SUBJECT: Report of USATECOM Project No LF-3216-42, Evaluation of
Computer, Ballistic, M13A1D, with Improved Illumination
for M60 Series Tanks

**SUBJECT: Report of USATECOM Project No. 1F-3216-42, Evaluation
of Computer, Ballistic, M13A1D, with Improved Illumination
for M60 Series Tanks**

SUBJECT: Report of USATECOM Project No 1F-3216-42, Evaluation
of Computer, Ballistic, M13A1D, with Improved Illumination
for M60 Series Tanks

COMPUTER, BALLISTIC, M13AID, WITH IMPROVED ILLUMINATION

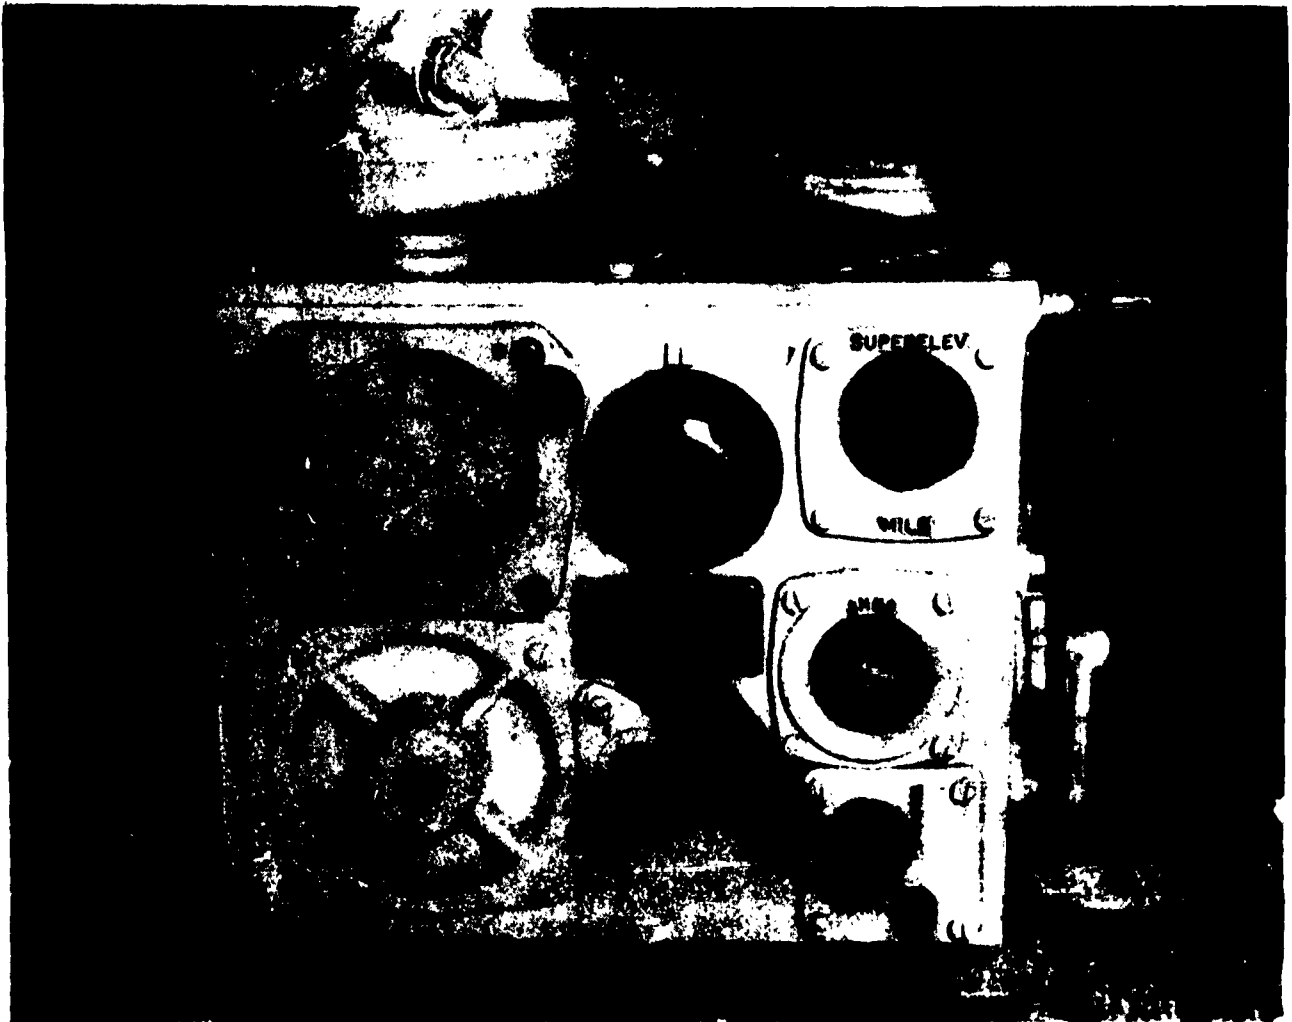
3. DESCRIPTION OF MATERIEL. The test item is a standard M13A1D ballistic computer which has been modified to incorporate illumination for the superelevation counter and improved illumination for the range scale. A folding ammunition selector handle has been provided in order to increase the gunner's elbow room in the M60A1 tank. This computer differs from the model tested under reference 2d in that the method of illuminating the range dial has been altered to improve the visibility of the inner and outer index marks. In addition, the conventional reset button and indicator light have been restored. Inclosure 1 is a photograph of the test item.

a. Range Dial Illumination. The white concentric rings with black strips surrounding the index marks reflected sufficient light to provide adequate illumination for both the range scale and the index marks.

b. Light Intensity. A single rheostat controls the intensity of all illuminating bulbs in the computer. When light intensity is set at the desirable level for reading the range dial, light omitted from the ammunition index tab window is excessive. This fault is considered a shortcoming.

c. Ammunition Selector Handle. The size and configuration of the folding ammunition selector handle are acceptable. Improvement of the handle by enlarging it is precluded by the location of the reset button indicator light.

a. The condition whereby proper illumination of the range dial results in excessive light from the ammunition index tab window was reported in reference 2d and not corrected in the present test item.

a. The remodified M13A1D ballistic computer be further modified, if practical, to correct the shortcoming noted in paragraph 5b.
